Supplementary Environmental Impact Statement *Twin Bonanza 1 Gold Mine*

April 2014

Document Control Record

Figure 2. Revised expansion footprint of existing accommodation village and associated infrastructure.

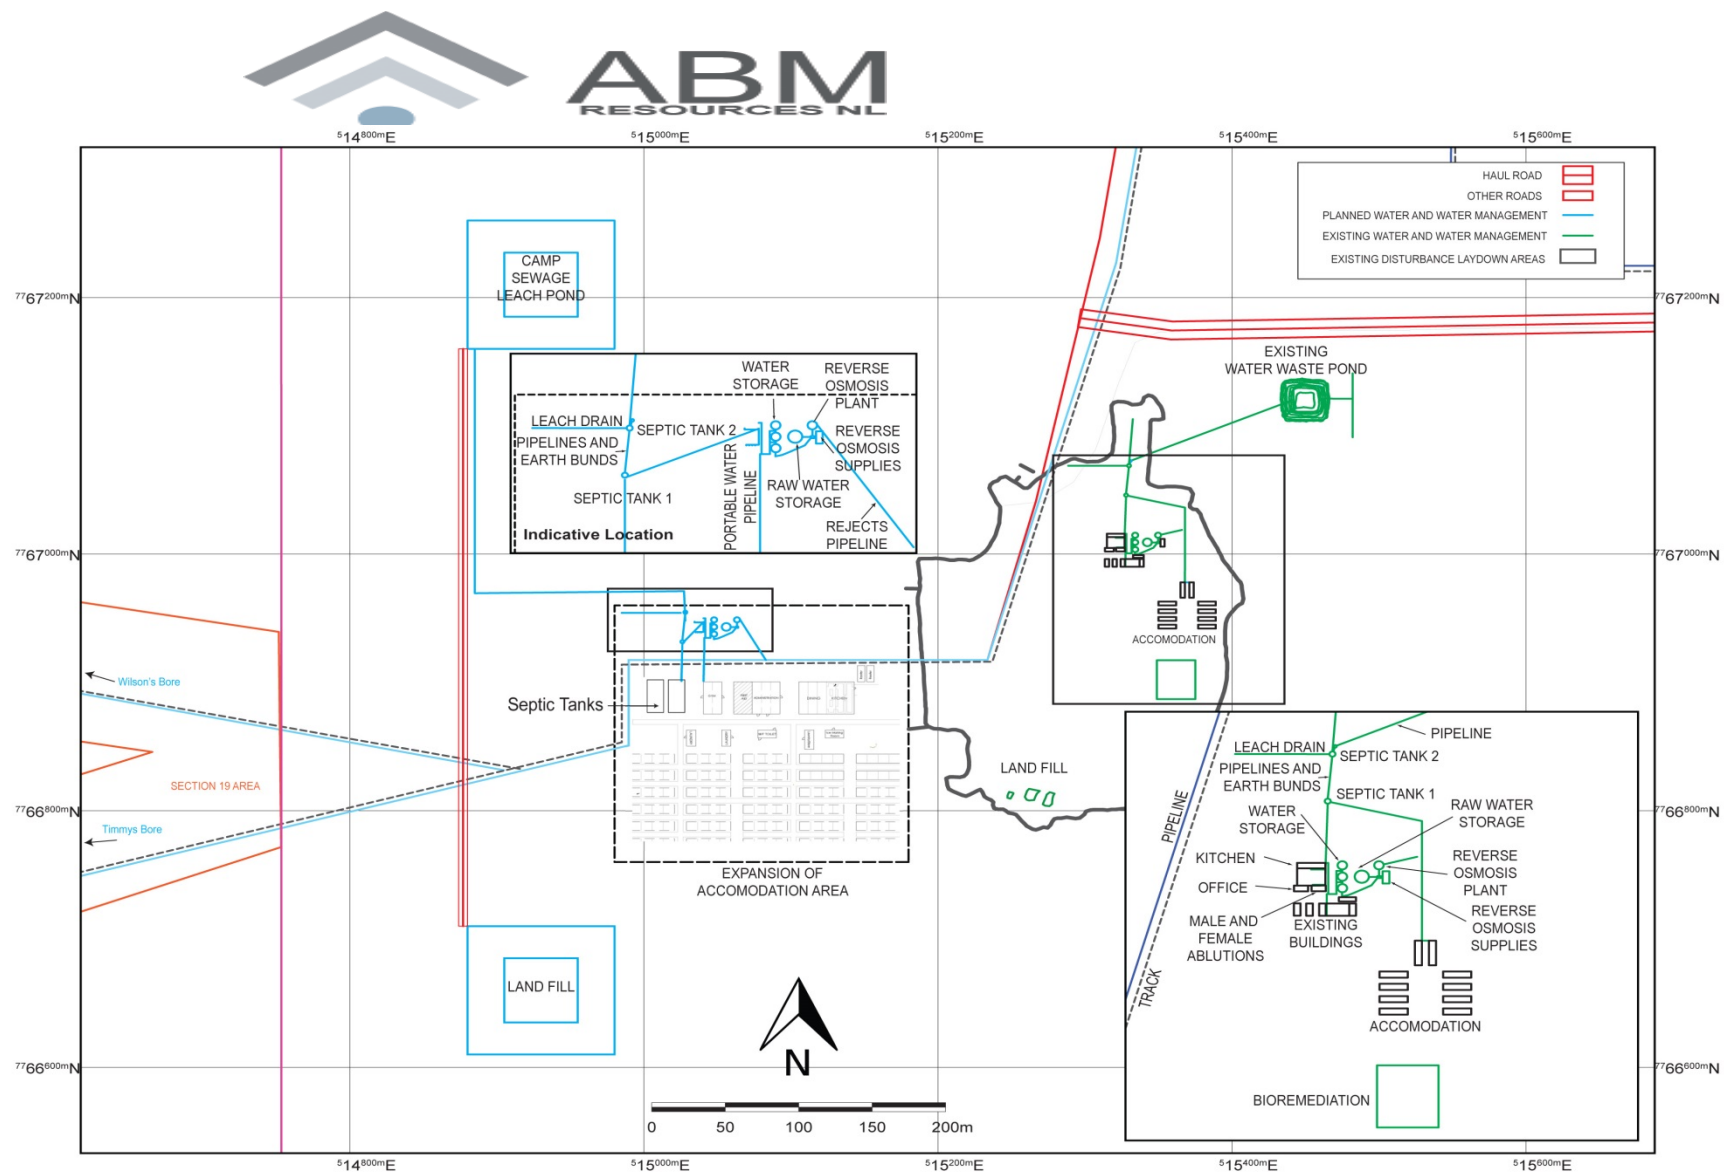
Comment Number	EIS Section	Comment	Related Comment and/or Appendices
18	Figure 9.1, Chapter 9	<i>The Camp Sewerage Leach Pond and Landfill are located close to the boundary of the MLA 29822. Any leachate outside the MLA may require reporting under the Water Act and the Waste Management Pollution Control Act. Adjustments to the proposed locations of these facilities should be considered.</i>	NA

In the Draft EIS, the landfill and camp sewage leach pond were located in close proximity to the western boundary of the Mineral Lease 29822. Based on the advice from the Department of Mines and Energy (Comment 17, Section 5) the locations of both the sewage pond and landfill have been moved to the east to provide further separation between the facilities and the tenement boundary for ongoing management (Figure 2).

In response to this comment, ABM has reviewed the location of the leach pond and landfill and has moved their locations towards the east as detailed in Figure 2, this will provide greater separation from the tenement boundary.

Figure 3. Revised stage three layout with indicative waste rock dumps and tailings dam for the Twin Bonanza Project.

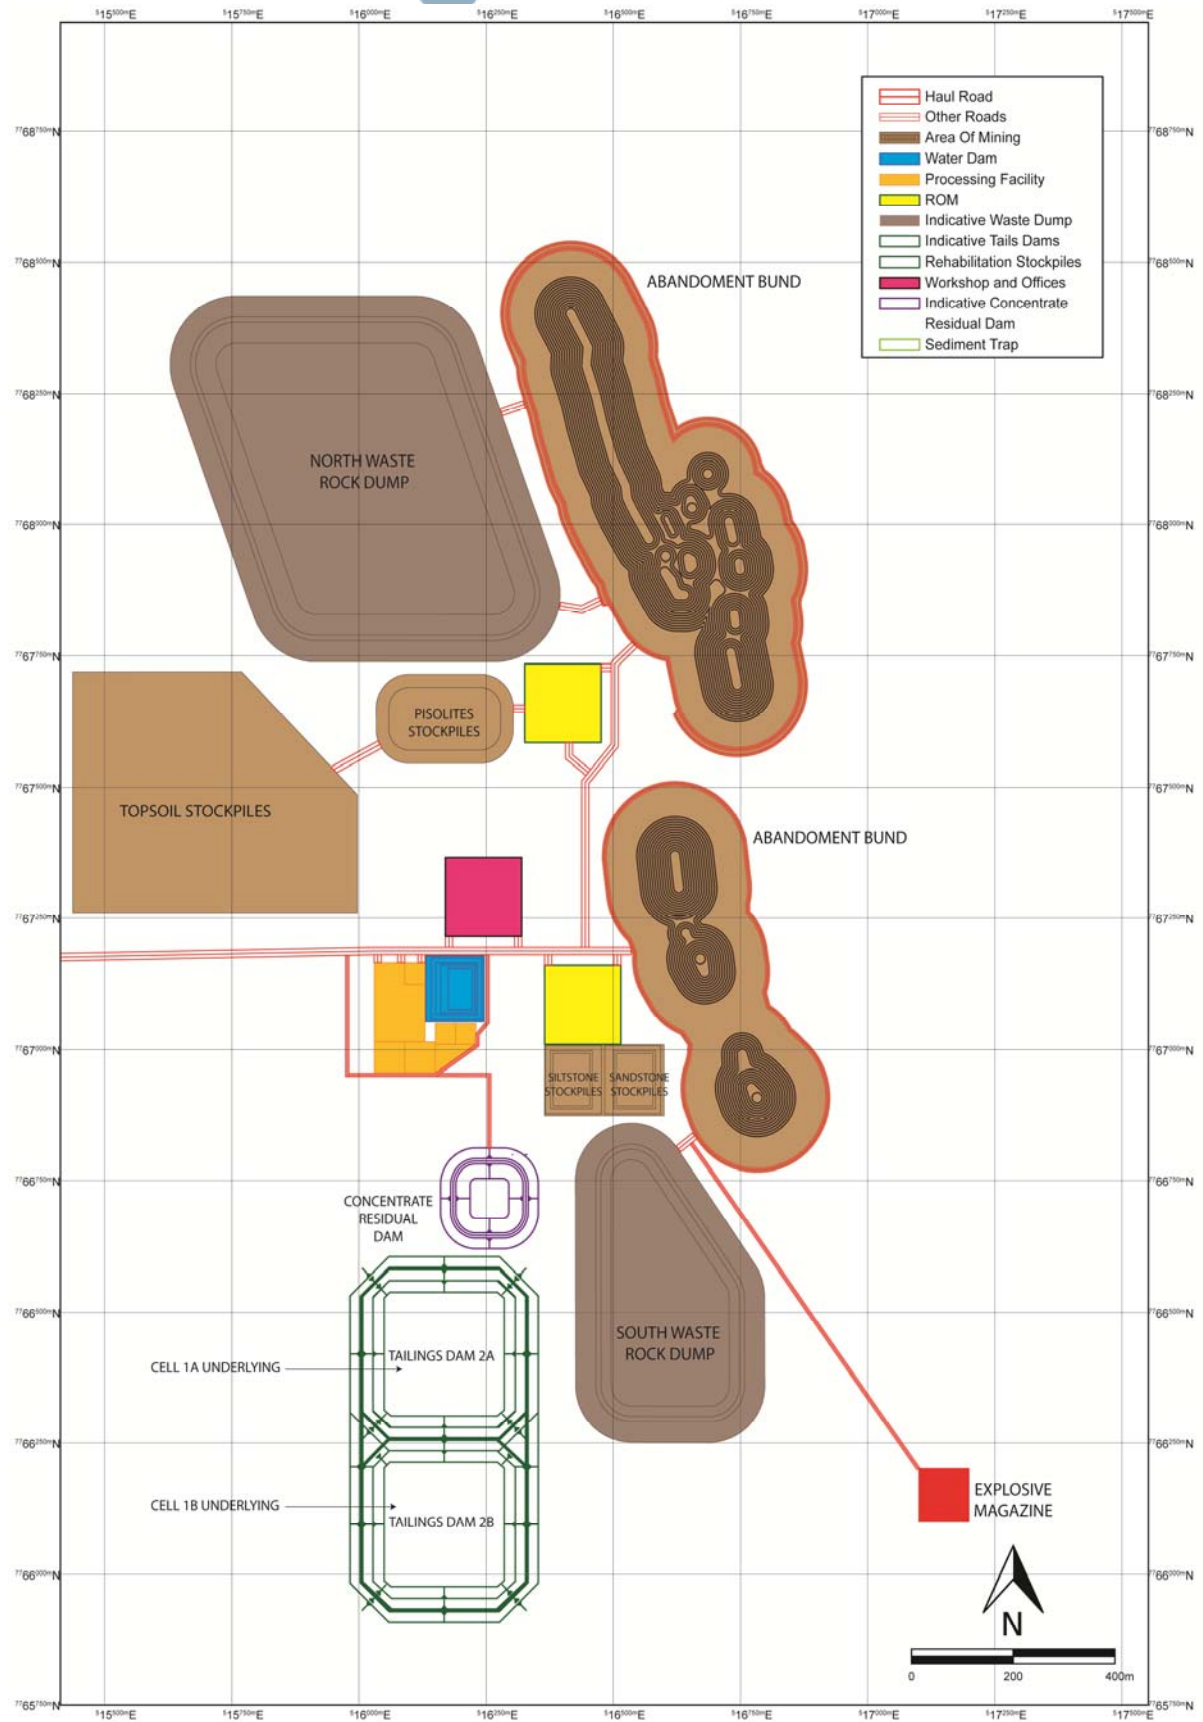
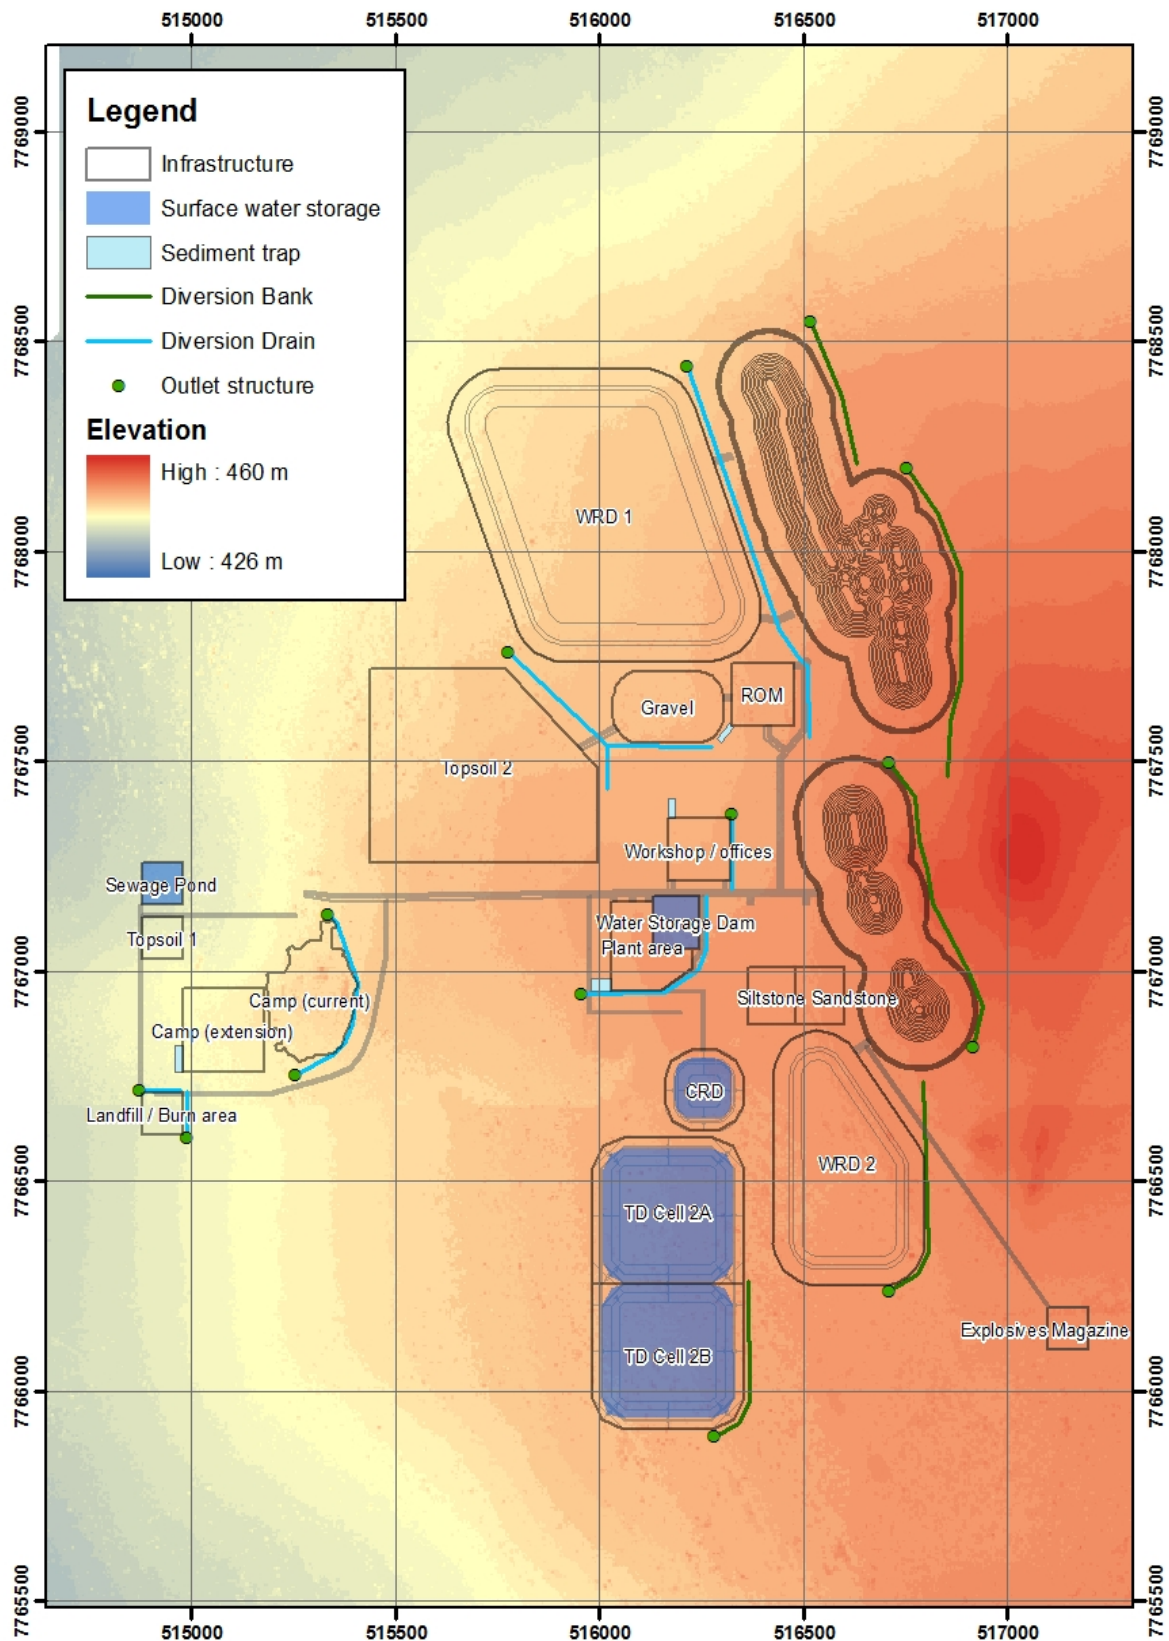
Comment Number	EIS Section	Comment	Related Comment and/or Appendices
26	Section 7.3.1, Chapter 7	<i>"Four sediment traps are required, and these will be installed at the processing plant, workshop/office area, ROM pad, and camp (Figure 7-5)."</i> <i>The sediment basins for the workshop/office area and the ROM pad are directly uphill of the topsoil and gravel storage areas.</i> <i>Considering that they are flow-through cells, the supernatant that overtops the sediment basin will immediately run into the topsoil and gravel storage areas, which will immediately release more sediment and cause issues down gradient. These sediment basins need to have their spillways located in an area that will direct any supernatant to an undisturbed area, and the spillway must be designed so that it reduces the chance of erosion occurring when supernatant leaves the sediment basin.</i>	Comment 33

Comment Number	EIS Section	Comment	Related Comment and/or Appendices
27	Section 7.3.1, Chapter 7	<i>There is a diversion drain that appears to pass through, or very close to the CRD in Figure 7-5. What is the risk of this drain eroding or overtopping into the CRD?</i>	NA

Comment Number	EIS Section	Comment	Related Comment and/or Appendices
33	Appendix E	<i>With regard to two sediment traps and a diversion drain discharge on the western (upslope) side of topsoil area 2, the Department recommends that the northern side of the topsoil area be reconfigured to allow an adequate path for this discharge to flow unimpeded in a downslope (NW) direction, and a diversion bund to separate the topsoil area from this flow path. The Department also recommends suitable sediment controls around the NW corner of Waste Rock Dump 1 (WRD 1) and the NW corner/western side of the Topsoil 2 area.</i>	Comment 26

To enable the unimpeded flow of water from the sediment traps located at the workshop and ROM pad on the eastern side of topsoil stockpile 2 (As discussed in comment 25 and 32, Section 5). Topsoil stockpile 2 was moved to the west, with the north-eastern corner reconfigured to allow surface water to flow between the stockpile and the Northern Waste Rock Dump (NWRD). This will prevent water ponding against infrastructure. In addition, a drain is to be positioned between the topsoil stockpile and NWRD with bunds positioned in the area at the base of each stockpile to capture any liberated sediment (Figures 3 and 4).

The site layout has been revised to allow for the unimpeded discharge of water to undisturbed areas and to avoid flowing against stockpile areas. In addition, along the margins of the topsoil and rehabilitation stockpiles either bunds or whoa boys will be developed of competent material. Each of

the spill ways from the sediment ponds will be broad rock armoured chutes to dissipate water velocities to thus limit erosion at discharge points. The revised layout is presented in Figures 3 and 4.

The site layout has been revised to provide further separation between the diversion drain and CRD (Figures 3 and 4). The risk of the drain eroding or overtopping into the CRD is deemed to be low based on the measures and engineering considerations that will be put in place. These measures can be detailed as follows:

ABM have modified the design of Topsoil Area 2 to accommodate the flow of surface water from the approximately 13 ha upslope catchment area, which includes diversion water and sediment basin discharge from the ROM Pad and Workshop areas (Figures 3 and 4). Small drains will be installed along the north-eastern edge of the Topsoil Area 2 and along the southern edge of the pisolite stockpile area to further facilitate proper drainage and help ensure the integrity of the stockpiles. These drains will each be approximately 1.1 m deep, and have been designed as non-permanent structures to convey the expected 1:100-yr peak flow of approximately 7.3 m³/s.
